PRELIMINARY SAFETY EVALUATION REPORT

TRANSNUCLEAR, INC.

STANDARDIZED NUHOMS® HORIZONTAL MODULAR STORAGE SYSTEM FOR IRRADIATED NUCLEAR FUEL

AMENDMENT NO. 10

Figure 4.5 Effective Thermal Conductivity in the Radial Direction through OS200 Neutron Shield (SAR model; from p. U.4-10, Section U.4-2)

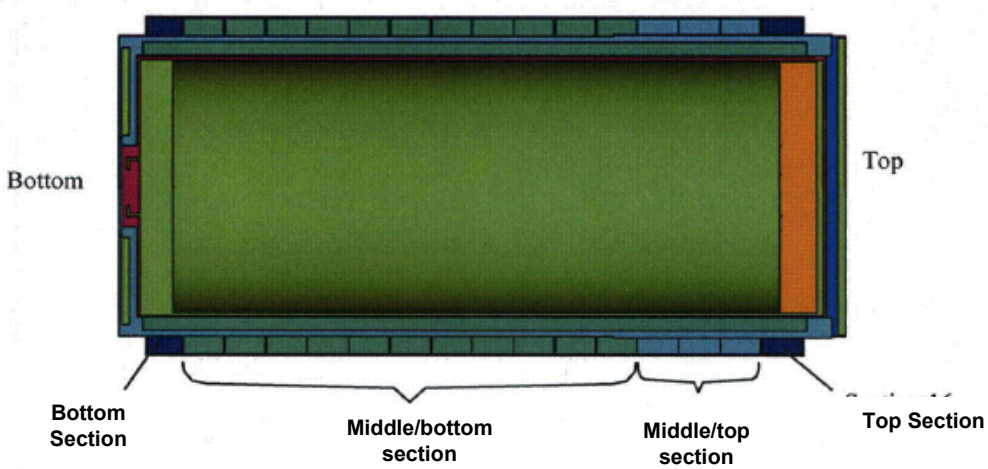
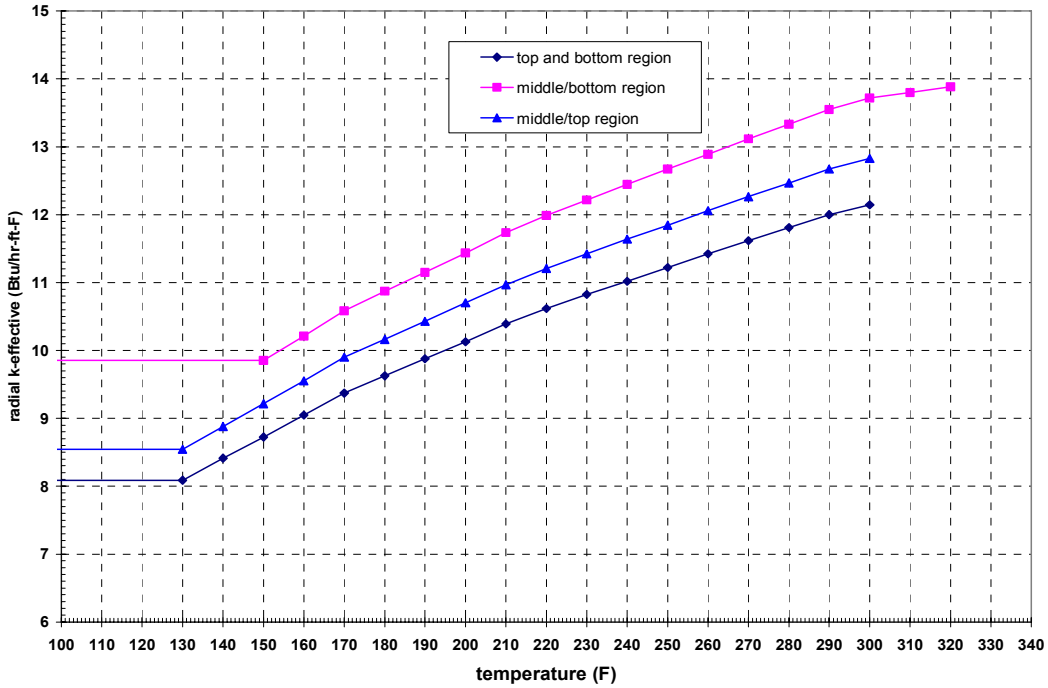
The k-effective model used in the analyses in the SAR formulates the effective conductivity as a function of temperature, and for application to the horizontal transfer cask, defines slightly different relationships for different axial regions of the neutron shield annulus. Figure 4.4 illustrates the location of each of these regions along the neutron shield annulus, and Figure 4.5 shows the k_{eff} values[1] defined in each region as a function of temperature. These two figures illustrate particular features of the SAR k-effective model for the neutron shield that could affect the accuracy and conservatism of transfer cask temperatures, and therefore the DSC temperatures, including the peak clad temperature. Specific concerns include:

- the assumption of radially uniform heat transfer rates around the full circumference of each segment of the neutron shield tank annulus
- the assumption that the effect of the stagnant regions at the top and bottom of the annulus (at the line of geometric symmetry) can be ignored

Figure 4.6 Effective Conductivity for Water-filled Neutron Shield (OS197 TC) from SAR

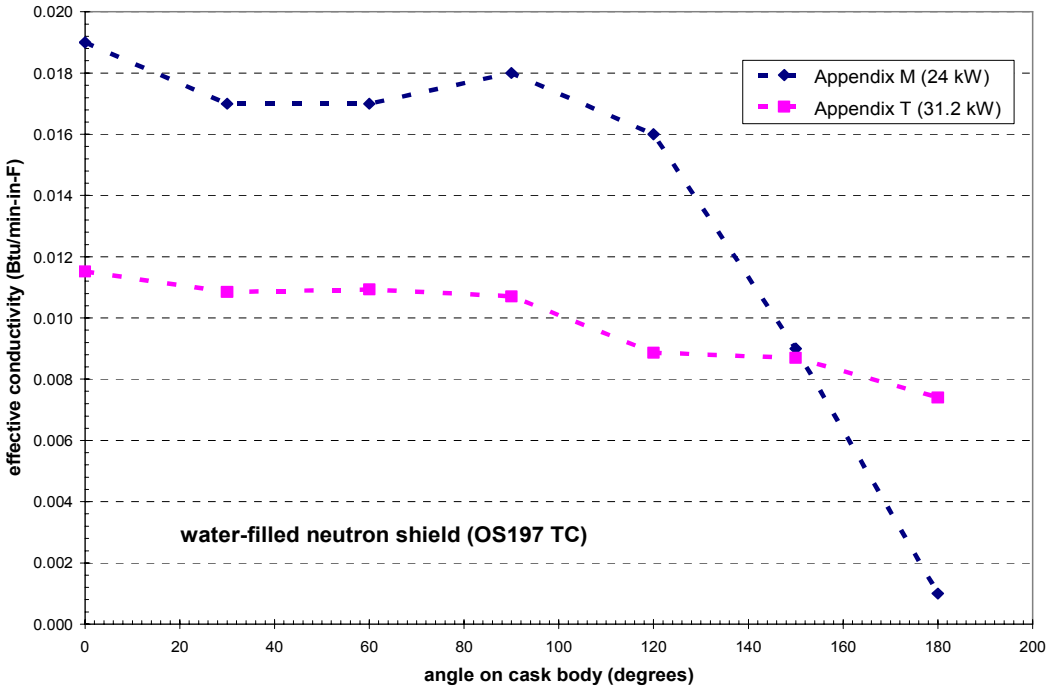
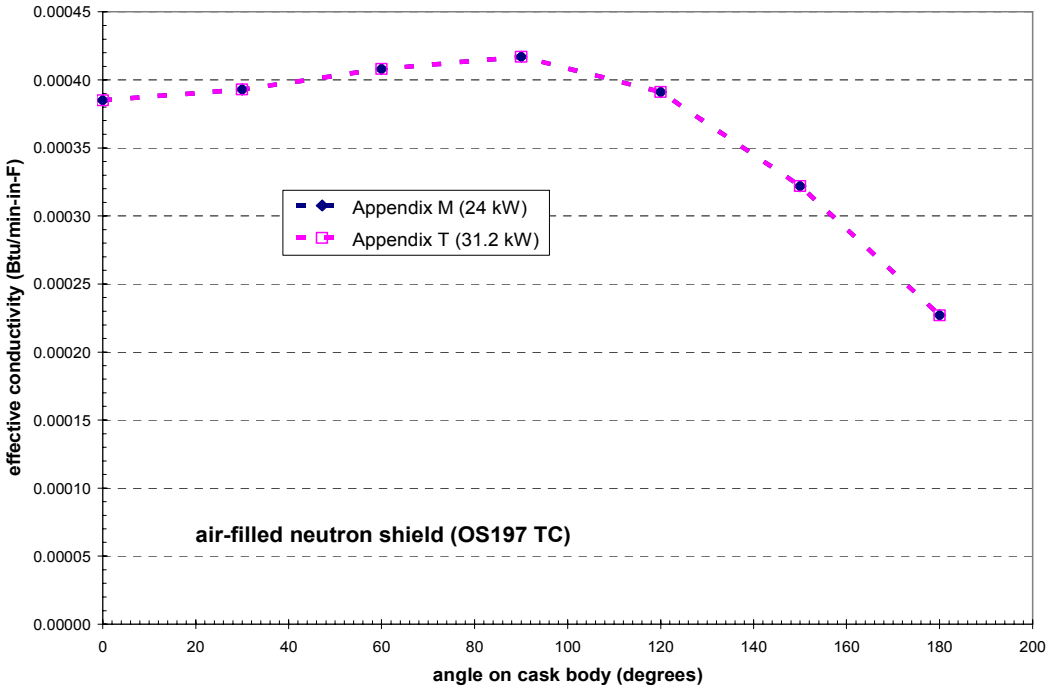
- Figure 4.6 compares the water-filled neutron shield effective conductivity from Appendix M to the values reported in Appendix T (Section T.4.2, item 17). Figure 4.7 presents a similar comparison for the air-filled neutron shield effective conductivity from the two sources. Figure 4.6 shows that the effective conductivity values reported in Appendix T of the SAR, for the water-filled neutron shield, are clearly not the same as the values reported in Appendix M. Figure 4.7, however, shows that the values are exactly the same for the air-filled neutron shield.

The applicant should justify this assertion, by calculating the appropriate effective conductivity values for the applications in Appendix T, and comparing the results obtained to the values reported in Appendix M.

Figure 4.12 Direct Comparison of DSC shell outer temperature results from StarCD model and ANSYS model[3] from the SAR.

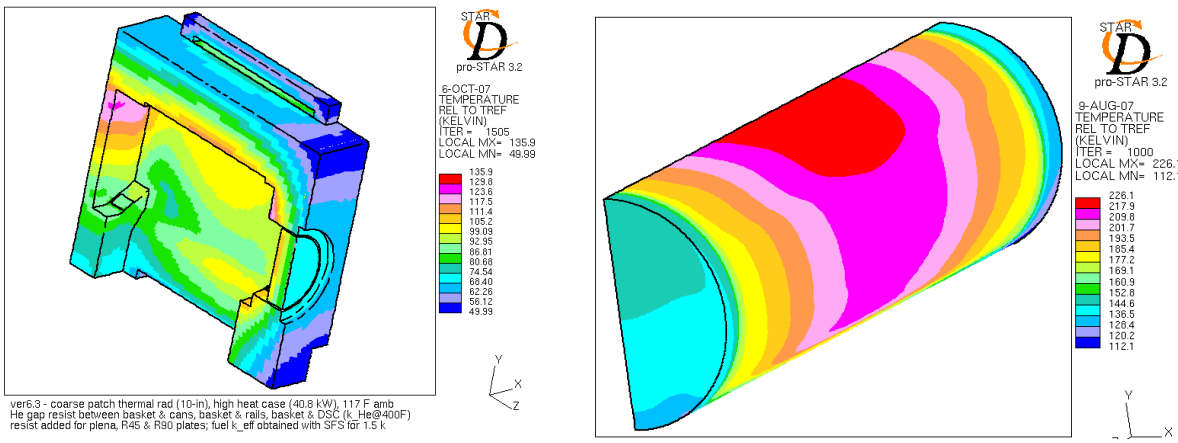
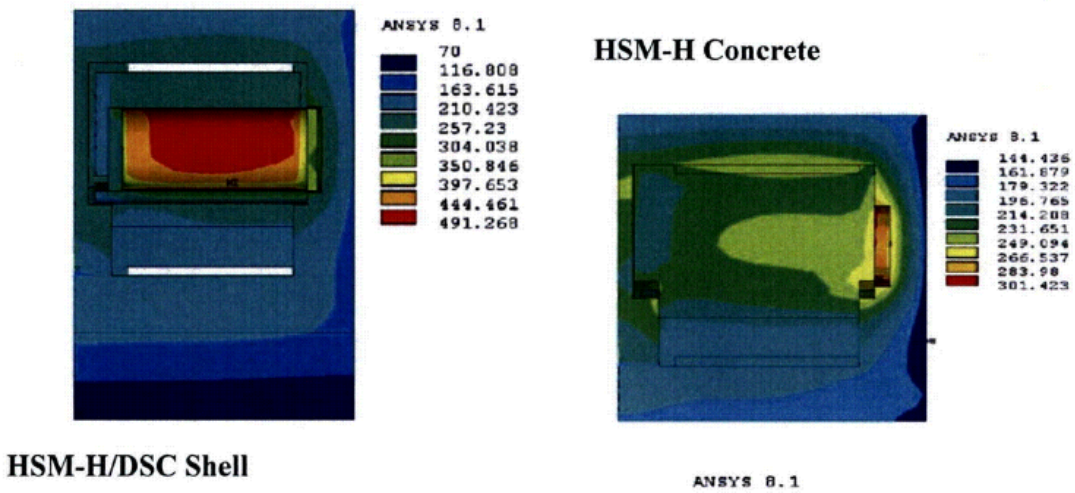
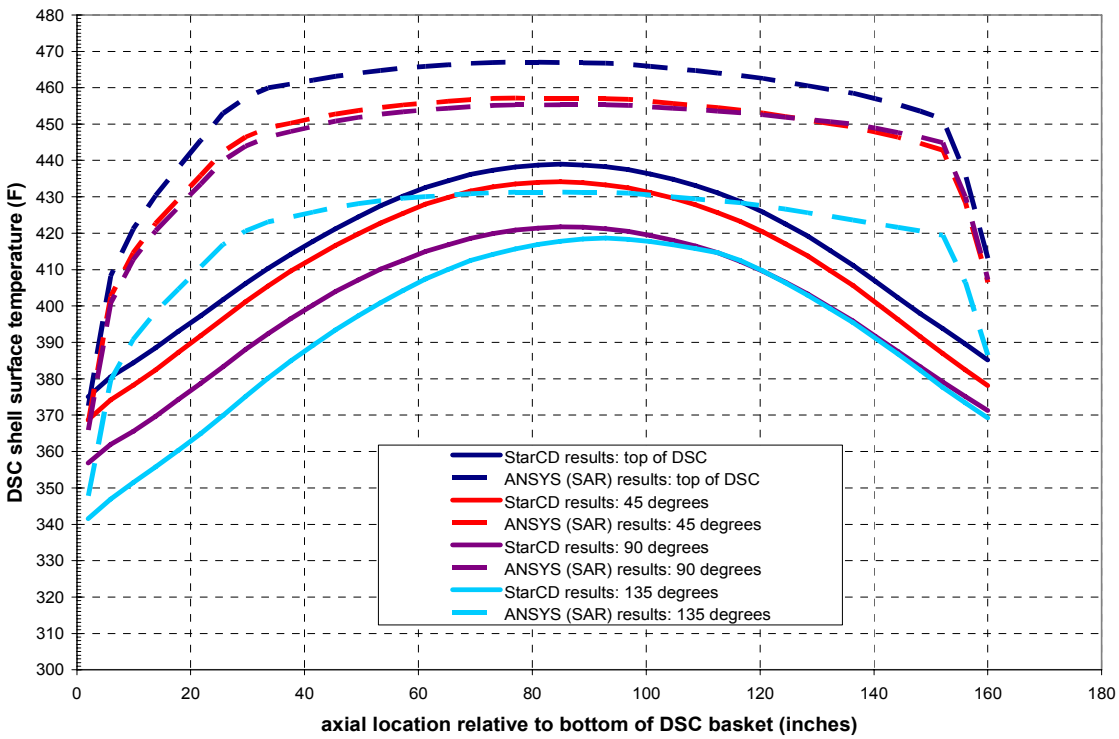
These results indicate that the modeling approach used in the SAR is conservative, in that it tends to over-estimate the DSC shell temperatures, and predicts a greater area of the DSC

[3] Note that the SAR temperatures in Figure 4.12 are from Rev. 0 of the SAR, before correcting the dead zone angle on the DSC shell from 4.2º to 18.9º. The overall effect of the correction is to increase the predicted peak DSC shell temperature by 18-25 ºF. Because the one-dimensional stack effect model for air flow and air temperature boundary conditions is unaffected by this correction (see Revision 3 of the SAR), the general shape of the temperature profiles would remain unchanged.

Figure 4.14. Representative Results of CFD Modeling of OS200 Neutron Shield Segment Compared to SAR k-effective Model of Neutron Shield

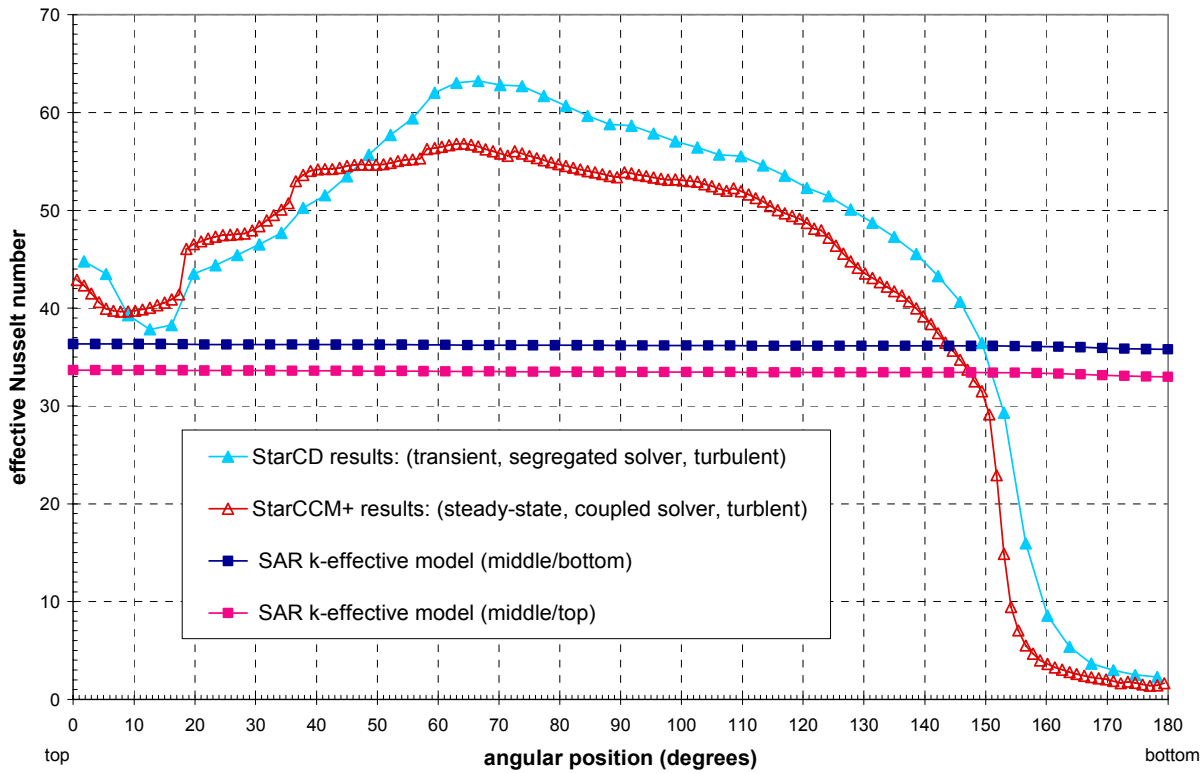
The Nusselt number values should not be taken as a definitive description of the heat transfer behavior in the OS200 neutron shield. However, these results can be taken as a reasonably realistic picture of the distribution of the heat transfer rate around the circumference of the neutron shield annulus. This provides a basis for evaluating the k-effective model for the neutron shield, as presented in the SAR.

The CFD results show that although the k-effective model for the neutron shield may be conservative over most of the circumference of the horizontal annulus, it is clearly not conservative over the bottom portion of the tank, spanning a region of approximately 60º, centered on the vertical axis through the horizontal tank. This constitutes approximately one-sixth of the circumference of the tank, and as such, could significantly erode the conservatism for the neutron shield k-effective model.

Figure 4.15. Variation of Assumed Neutron Shield Effective Nusselt Number for OS200 TC

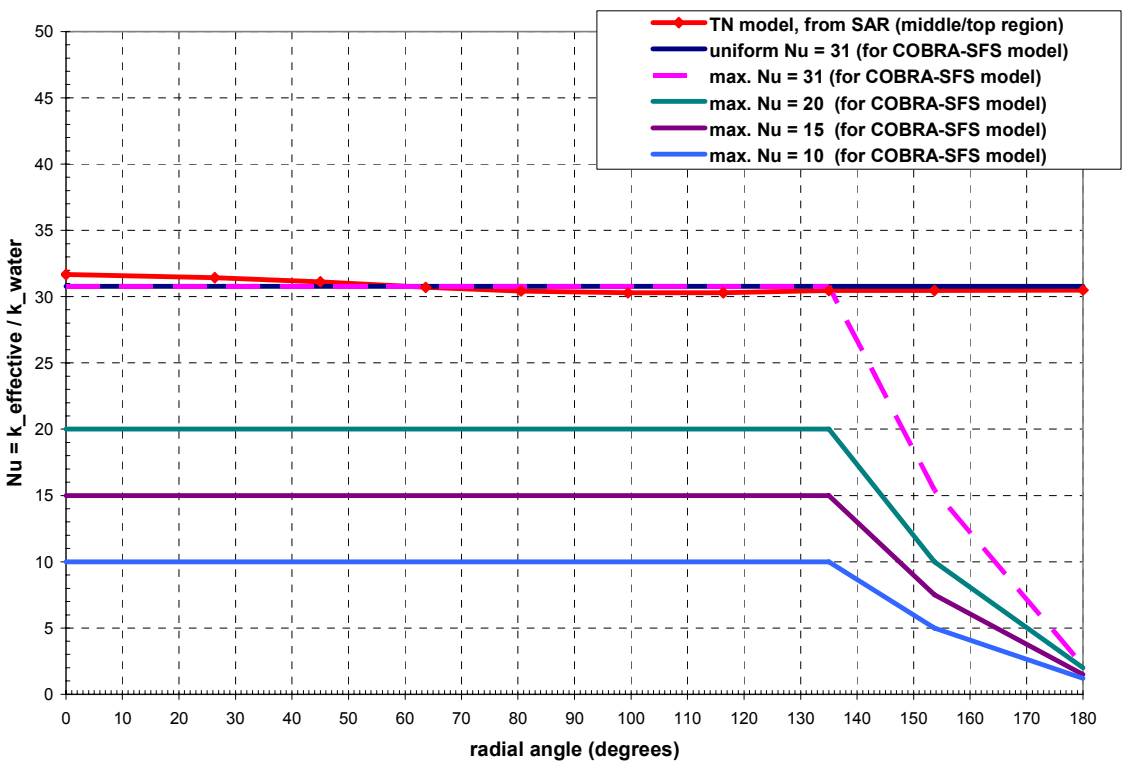
To evaluate the effect of a radially non-uniform Nusselt number on the peak temperatures obtained in the DSC, additional confirmatory calculations were performed with a detailed COBRA-SFS model of the DSC within the transfer cask. This model included the representation of the DSC that was used in the evaluations described above for confirmatory calculations in the storage module, but in addition included detailed representation of the transfer cask, including the non-uniform air gap between the DSC outer shell and the TC inner liner. The neutron shield tank was modeled in a manner similar to that used in the detailed SAR model, with an effective thermal conductivity defined for the neutron shield. Calculations were performed with uniform and radially varying effective thermal conductivity values, as illustrated in Figure 4.15. These calculations were performed for the limiting configuration[5] without forced air cooling, which is the DSC with Type 1 basket, HLZC #2, 31.2 kW.

The results of these calculations are shown in Table 4.24, compared to the corresponding limiting condition results from the SAR, and the Regulatory limit on peak cladding temperature for transfer conditions. For a Nusselt number corresponding to the SAR model (i.e., uniform Nu = 31), the COBRA-SFS results predict a peak clad temperature of 733°F. This is consistent with the bounding value of < 737°F reported in the SAR. For the case where this nominal Nu = 31 is assumed to decrease to a value of Nu = 2 in the bottom region of the neutron shield annulus, the COBRA-SFS calculation predicts a slightly higher peak clad temperature of 738°F. Further
